Lauberhorn C1 (C1L)

Differences between actual version PS1 and new version PS3

We herby apply for class II permissive change of FCC ID: RX2C1L due to the following changes:

1) Added "smart reset" circuit

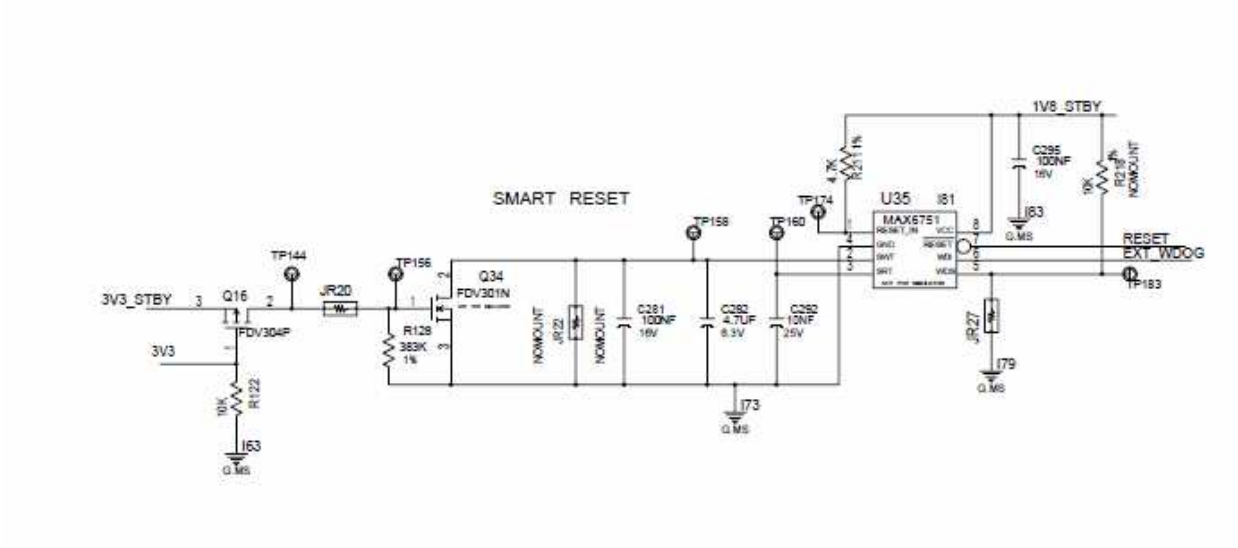
2) Added components (various parts):

JR51
JR54
JR23

3) Component modifications:

D15 changed to JR11
C205 changed to R280
